Sales, & Storage approved on 01/10/2015 for the Rigel 20 Fed Com 3H Battery. This corrective action is in response to the Notice of Written Order 18MB067W received from Michael Balliett on 01/11/2018. Rigel 10 Fed Com 3H (30.015-39725)				SENED.					
Rigel 10 Fed Com 3H (30-015-39725) NWSW Sec. 20, T19S, 31E Hackberry; BS NMNM0557729 (12.5%) NMNM63642A (12.5%), NMNM129587 (CA)									
	Rigel 20 Fed Com 4H NWSW Sec. 20, T19S, 31E	, ,	Acce	bred for tecon	NMOC	DISTRICT II-	ARTESIA O.C.D.		
14		is true and correct. Electronic Submission & For DEVON ENERC nitted to AFMSS for proces	SY PRODUCTIØ	N COM LP, sent AH MCKINNEY o	to the Carls on 04/19/201	bad			
	Signature (Electronic	: Submission)		Date 02/20/2	018_				
		THIS SPACE F	OR FEDERA	L OR STATE	OFFICE U	SE			
_A	pproved By JD2	hittock &	Z	Title 7	PET		10/24/18 Date 24/18		
	common as conflicted. If non- con adda.	were anneouslating national	E DOLLMANTON OF

DECISION & CORRECTIVE ACTION IN RESPONSE TO NOWO 18MB067W & AMENDMENT TO THE APPROVED CTB, OLM, SALES & STORAGE ON 01/10/2015

Off-Lease/CA Storage, Measurement and Sales of production Conditions of Approval October 24, 2018 Devon Energy Production Co. Rigel 20 Fed Com 3H, 4H,

Attachments: Description of the changes made to the battery Process Flow Diagram

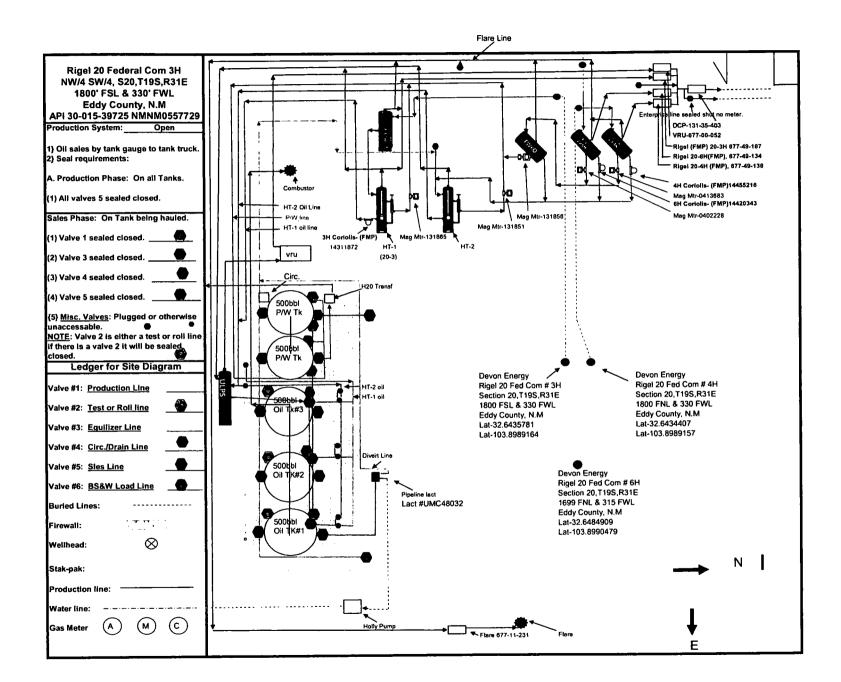
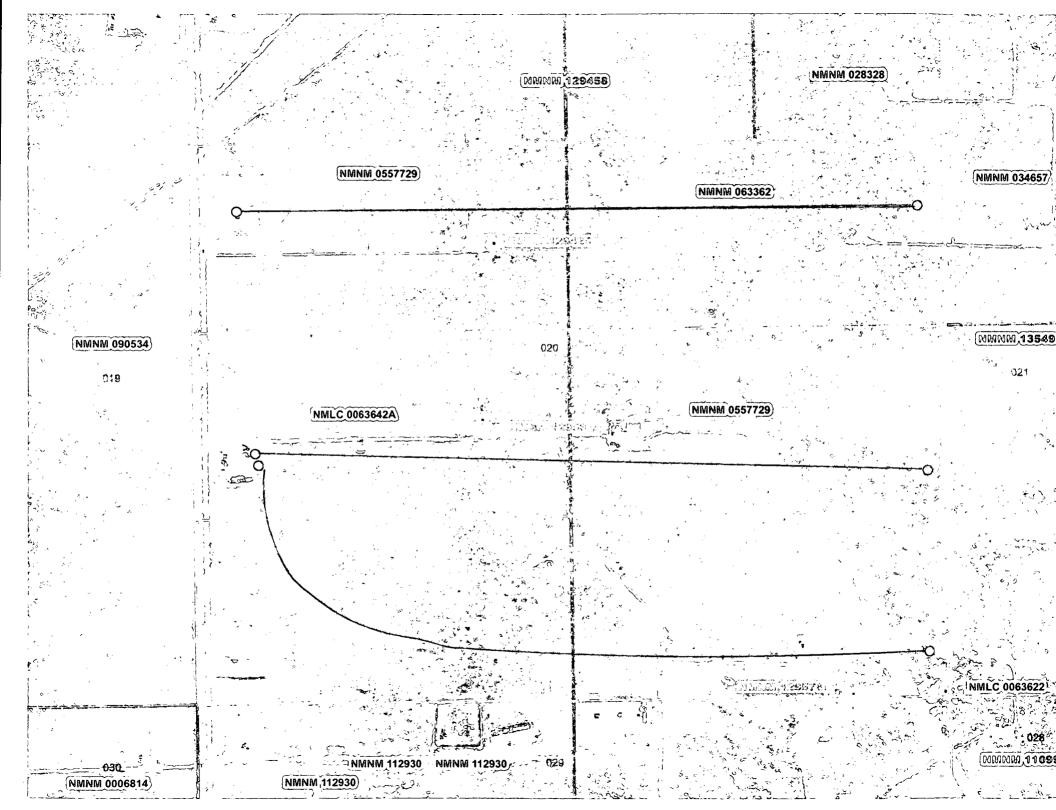
Devon will measure each wells production products (gas, oil & water)individually, so that the commingling issues are resolved at this battery. The VRU production will be allocated back to each well based on the oil production from each well on a monthly basis. Below is the proposed production path, along with the attached updated process flow diagram.

Devon will measure each wells production products (gas, oil, & water) individually, so that the commingling issues are resolved at this battery. The VRU production will be allocated back to each well based on the oil production from each well on a monthly basis. Below is the proposed production path, along with the attached updated process flow diagram.

- 9. VRU gas will be commingled and allocated back based on oil production as per write-up attached to request. This is also approved, with this approval. Gas vapors normally would be vented or flared.
